ADDENDA #1

Project Name: Woolfolk R&R – 3rd Floor
Project Location: Jackson, MS
Project Agency: DFA
Project Number: GS#362-067

Brown & Root Project: MS JOC-J457-0011

Addenda #: #1

ISSUANCE SCHEDULE		PN #21-026
Date	Description	SUPP. INSTRUCTION
2021.08.16	SI #1	SI-01
Drawn By:	AS	
Checked By:	CR	THIRD FLOOR WORK AREA 3A PLAN

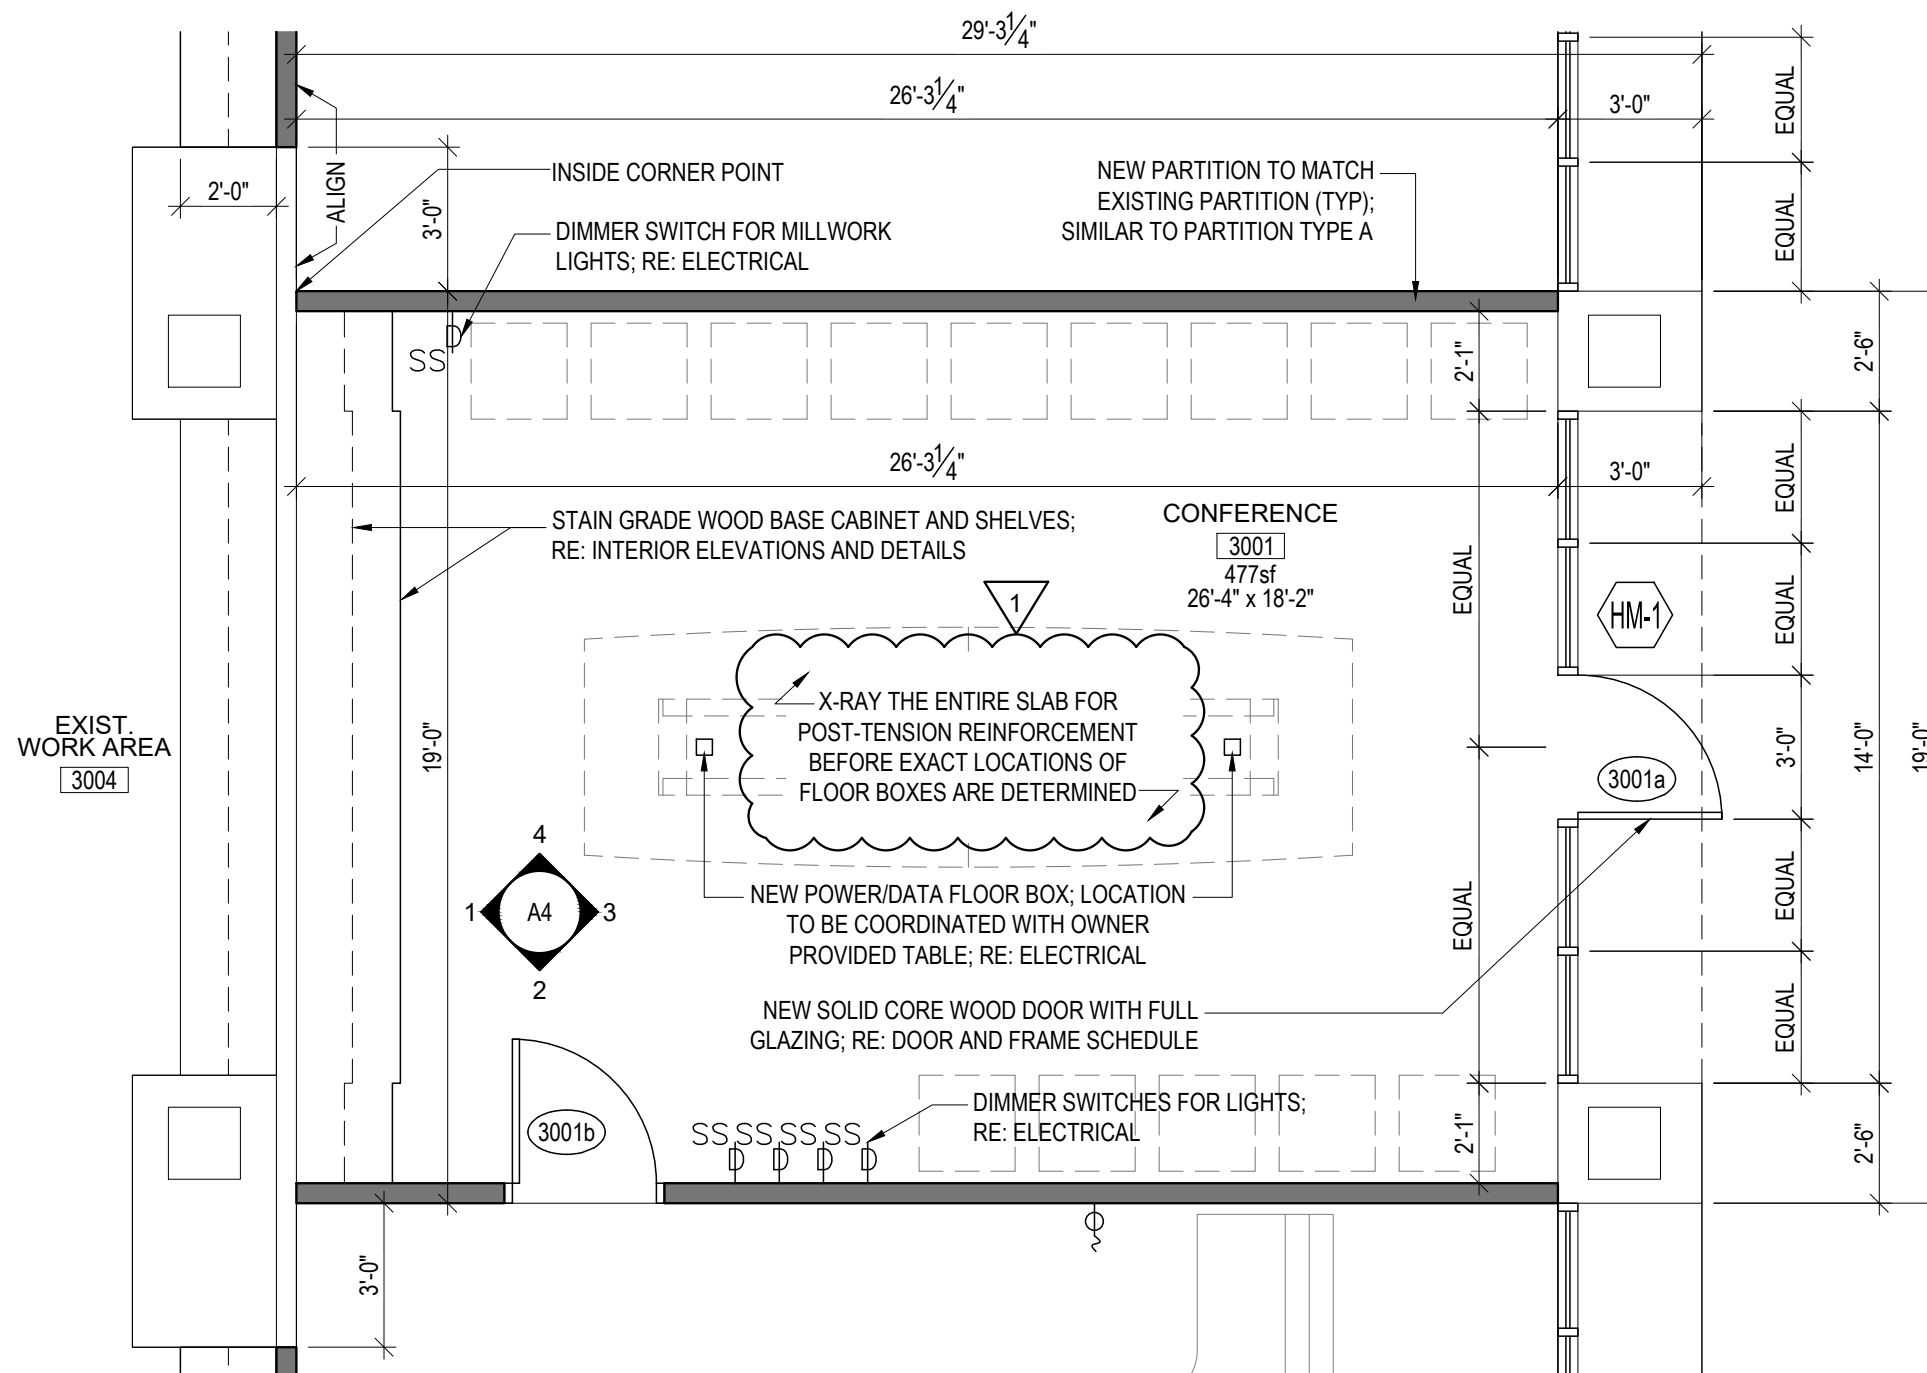
See attached drawing SI-01 to add x-ray of the slab before installing floor boxes to insure post-tensioned slab is not damaged in any way. Include in your proposal.
